March 11, 2024

TO : All Bidders
FROM : Bob Lavey
PROJECT : Nogales High School New Building and Aquatic Center
Project W2110000AR.41
DSA : 03-122782 / File 19-92
SUBJECT : Addendum 3

DRAWING NUMBER: **MA2.1**

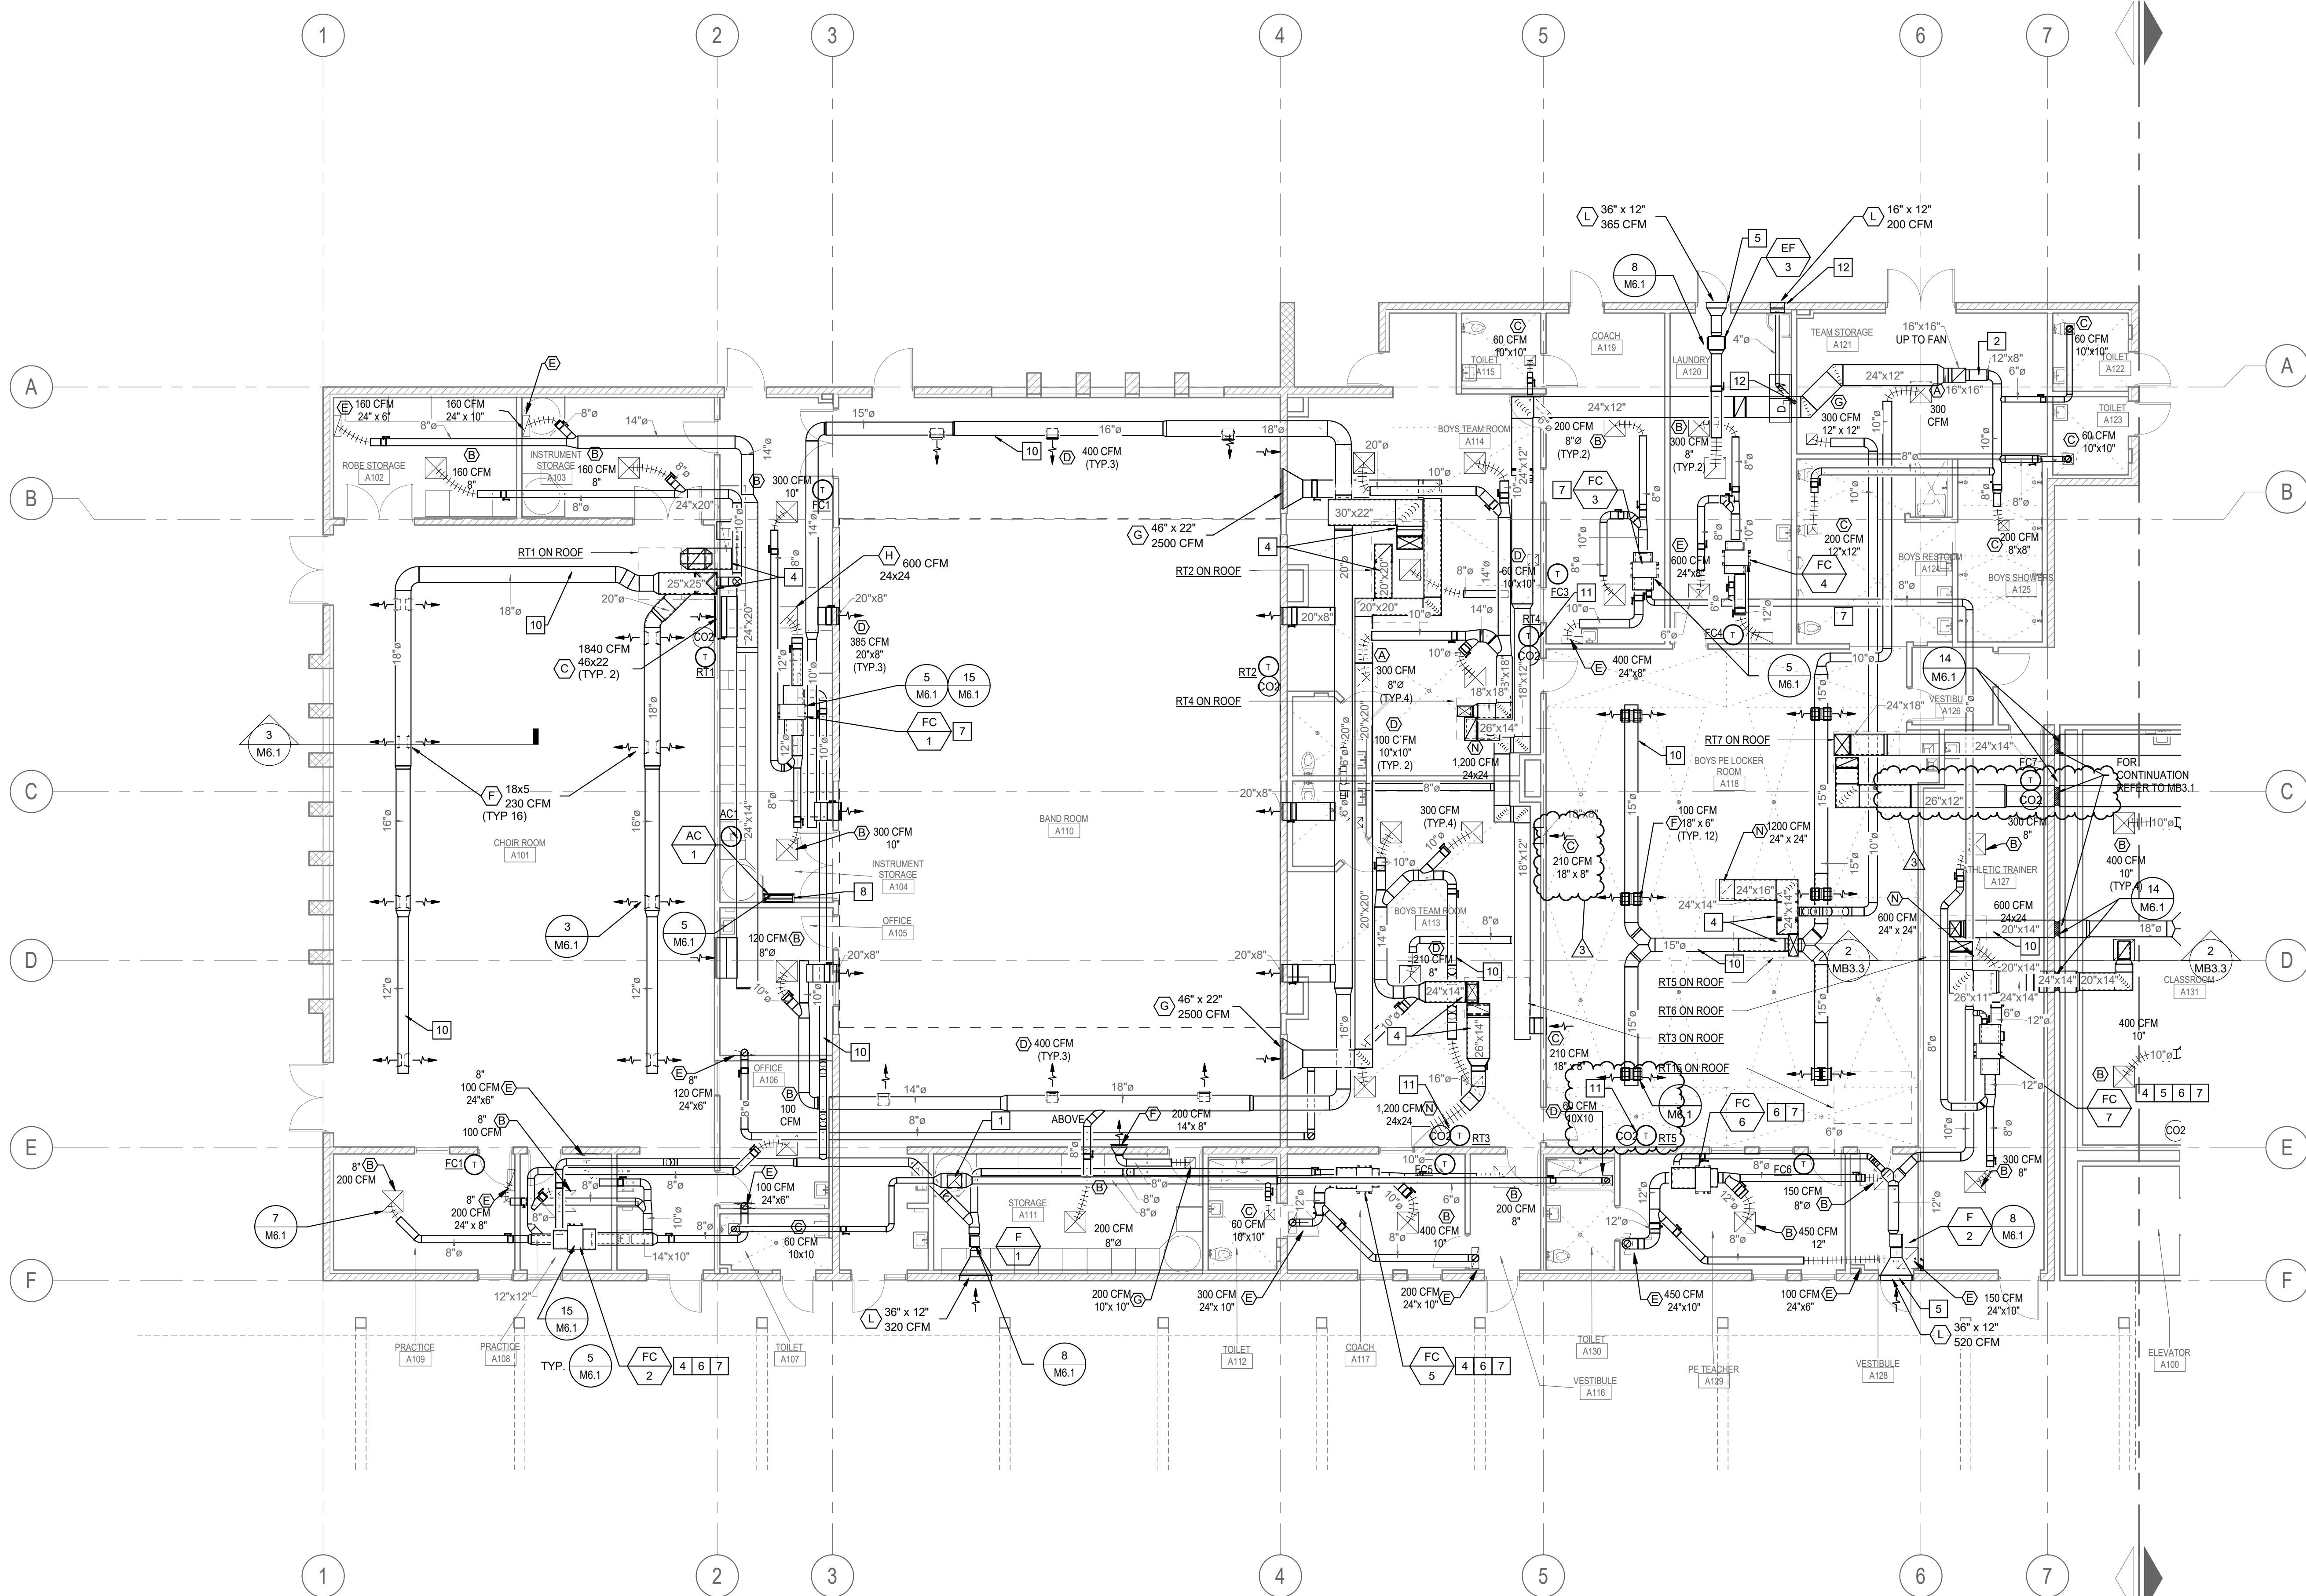
- A. Replace this drawing in its entirety with the attached Drawing MA2.1.
- B. Revised airflows at various outlets.
- C. Revised duct sizes in Athletic Trainer Room A127.
- D. Note 11 added regarding adding lockable covers for some thermostats.
- E. Note 12 added for dryer exhaust venting.

DRAWING NUMBER: **P1.1**

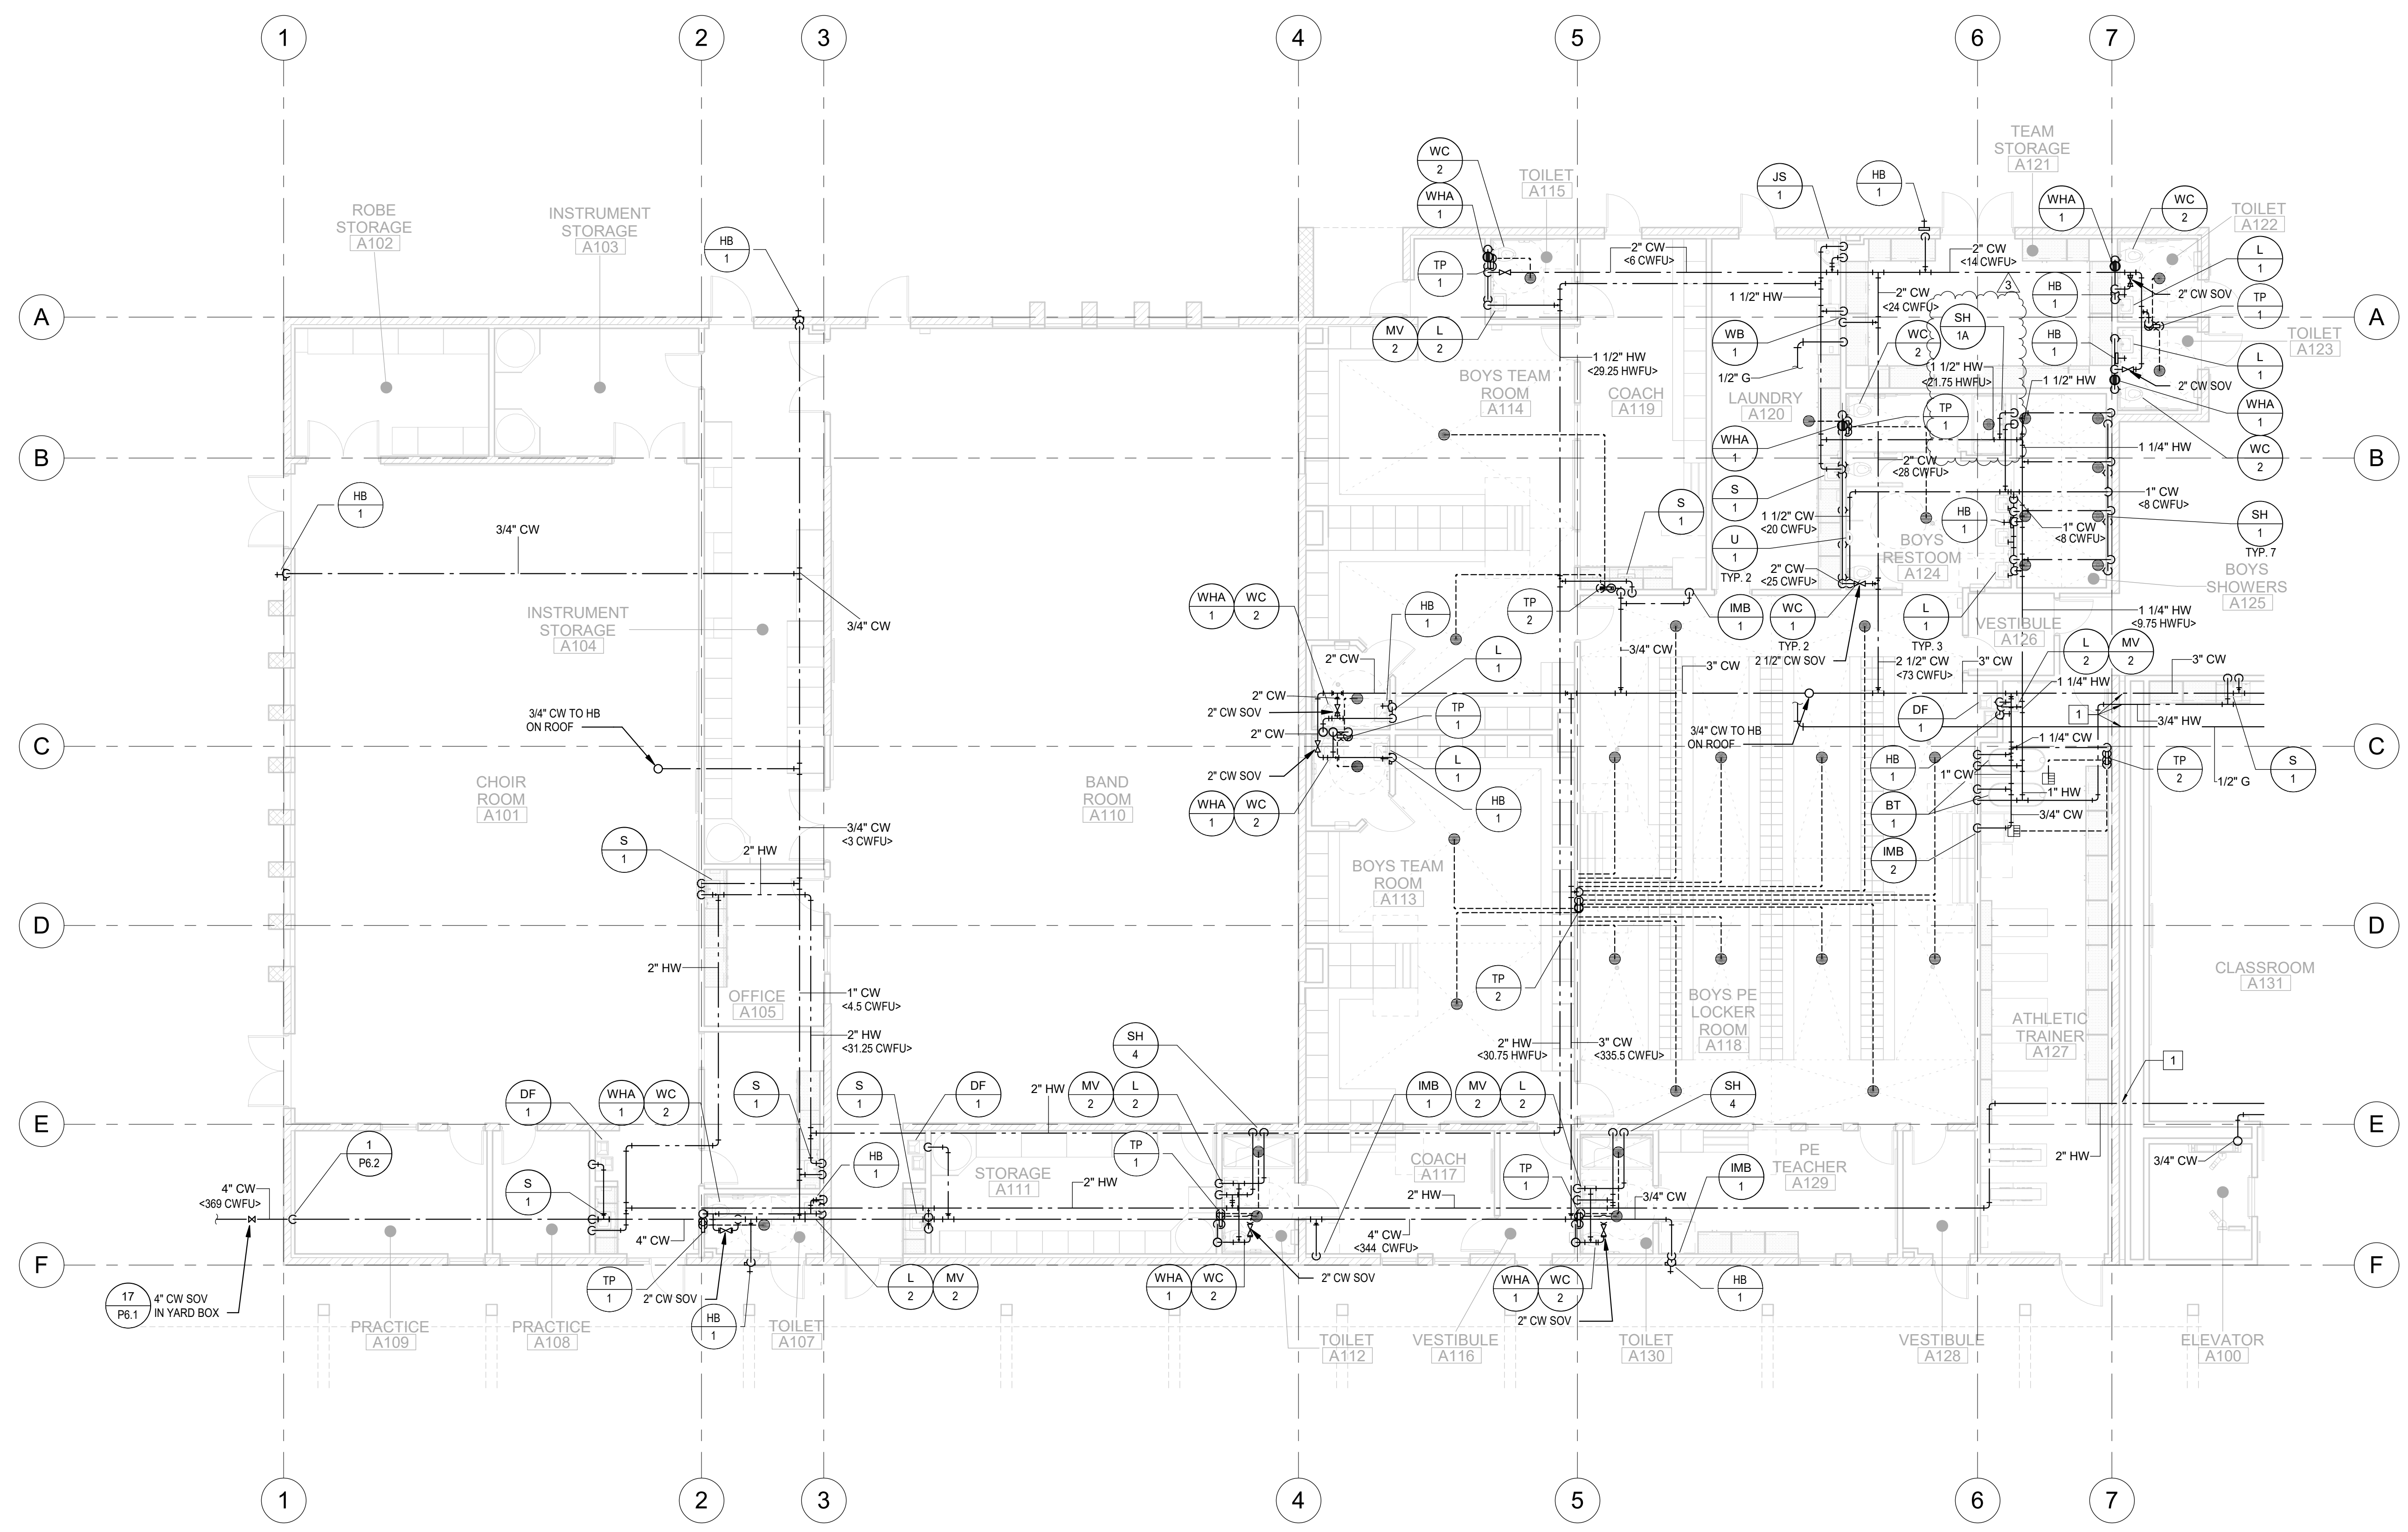
A. Replace this drawing in its entirety with the attached Drawing P1.1.

B. Gas isolation valves added to each branch in the construction zone.

DRAWING NUMBER: **P2.2.2**

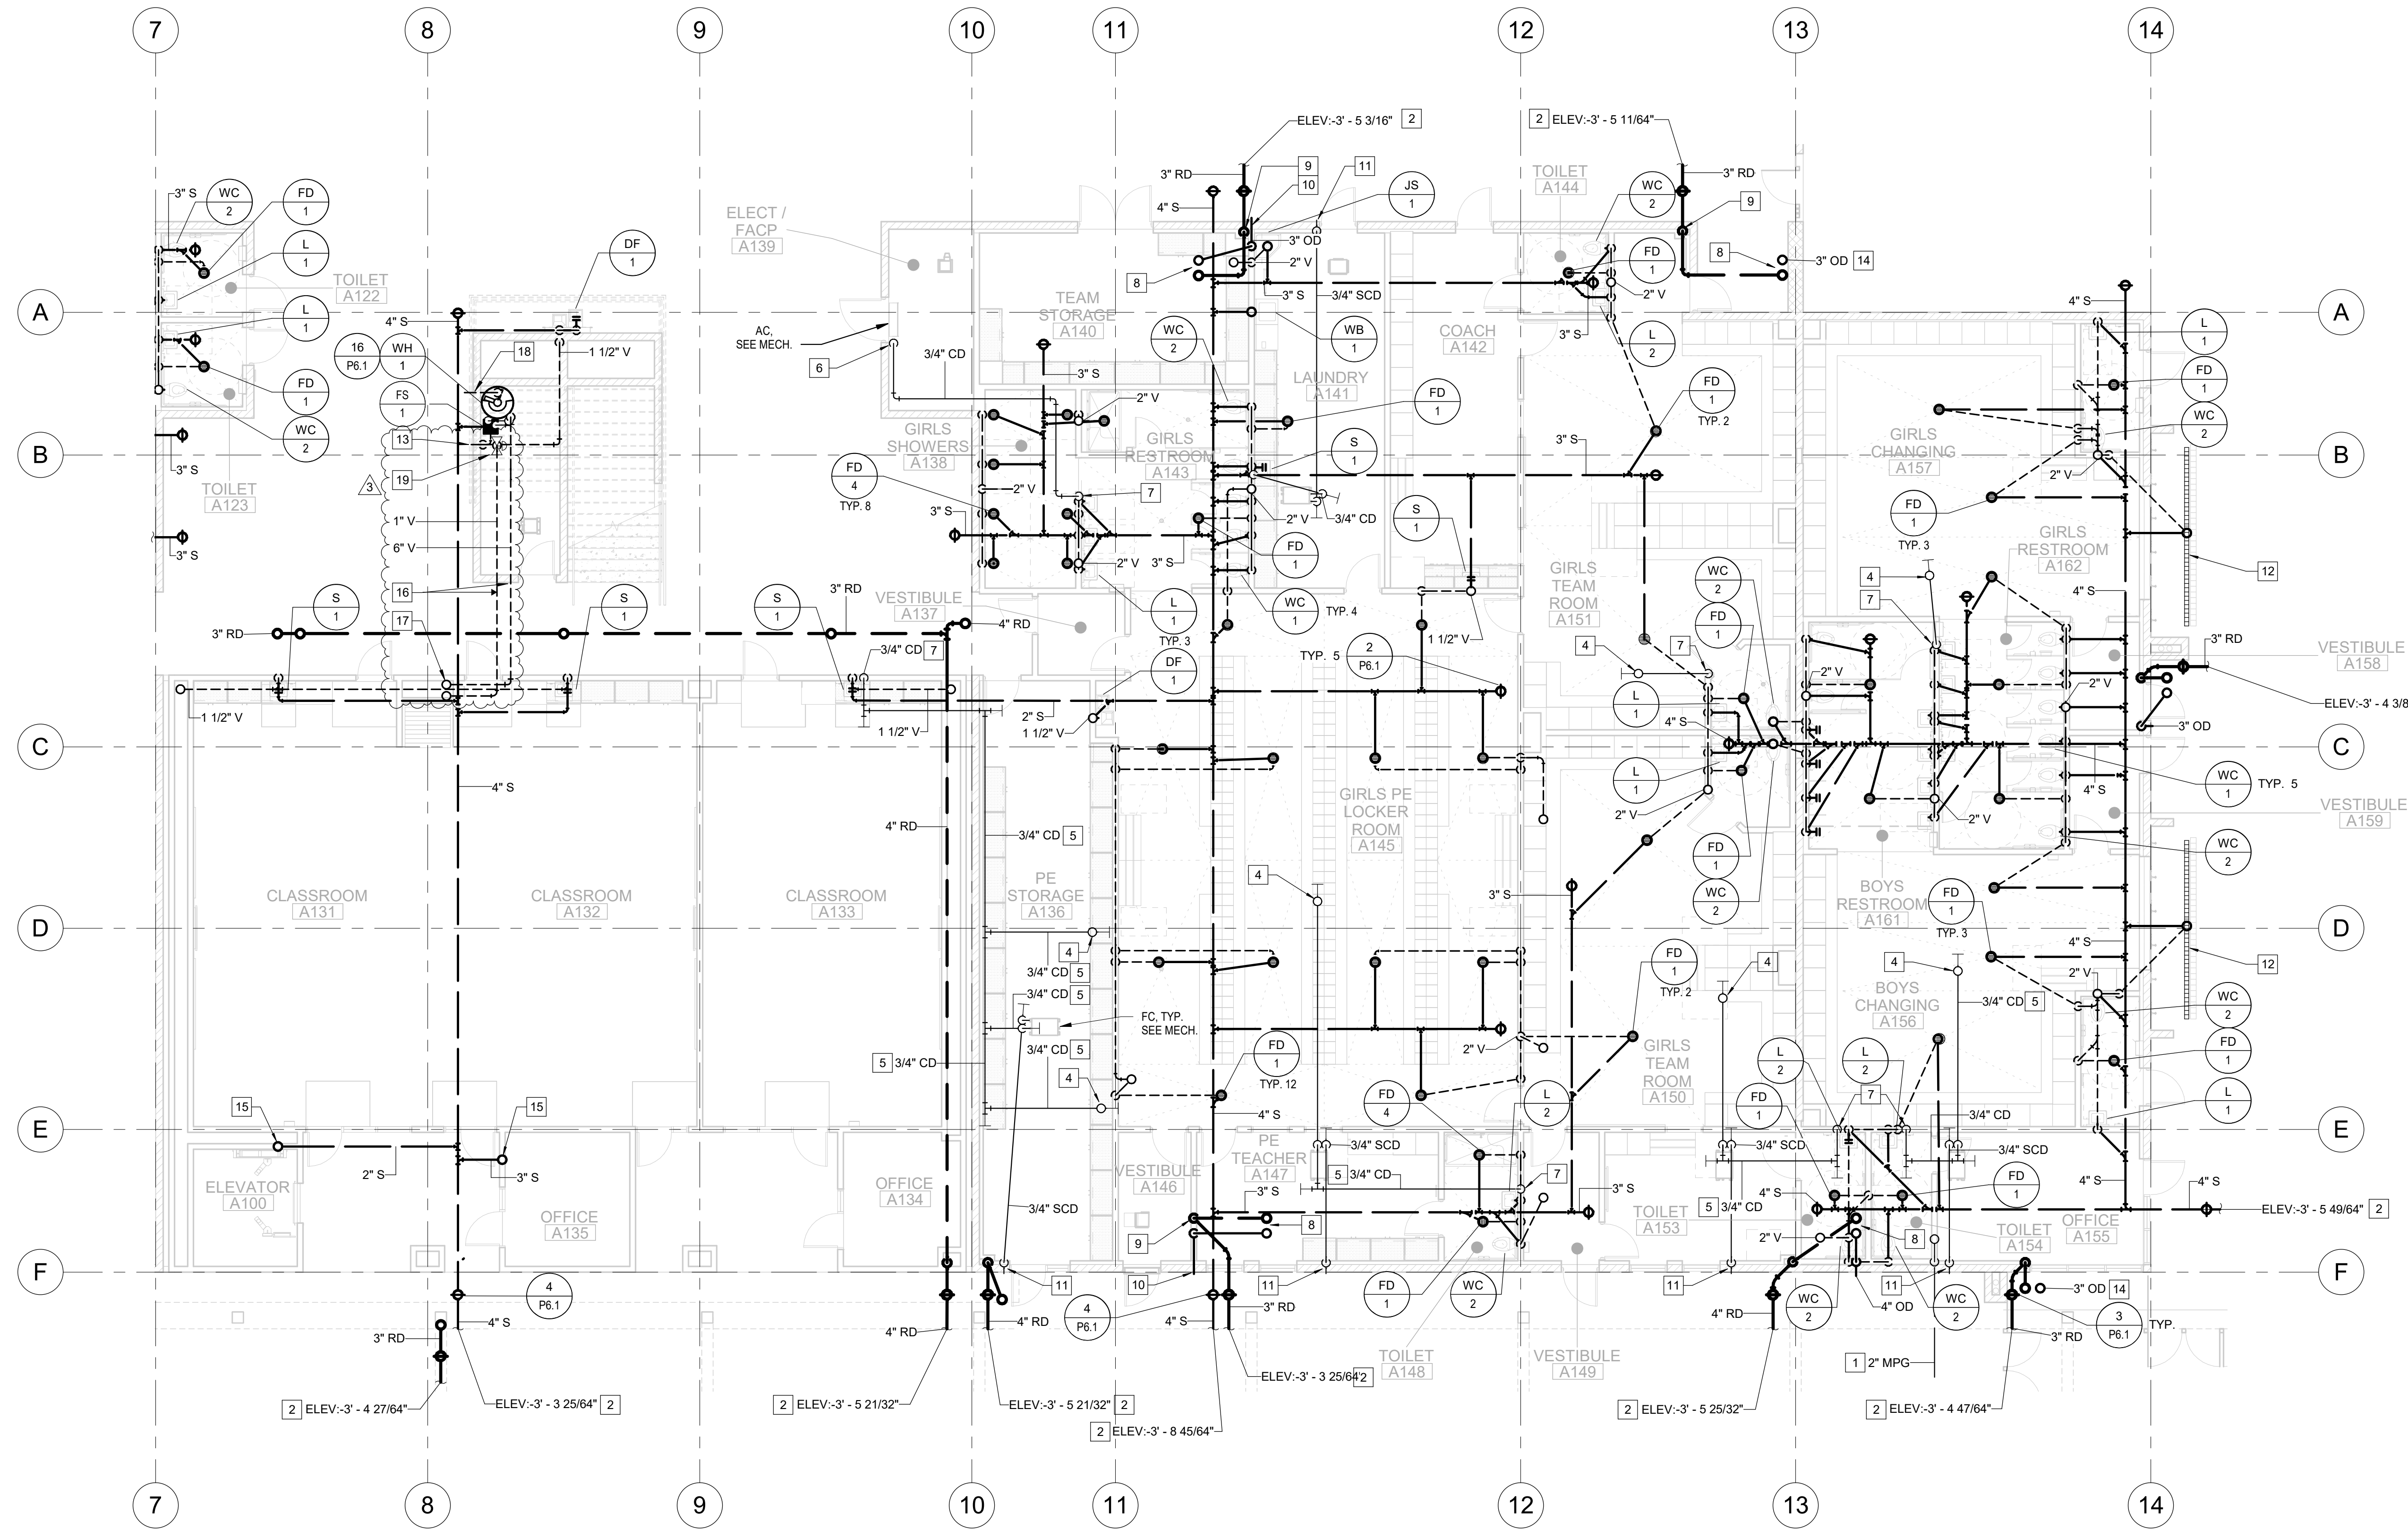
- A. Replace this drawing in its entirety with the attached Drawing P2.2.2.
- B. SH-4 changed to SH-1A in Boys Restroom A124.
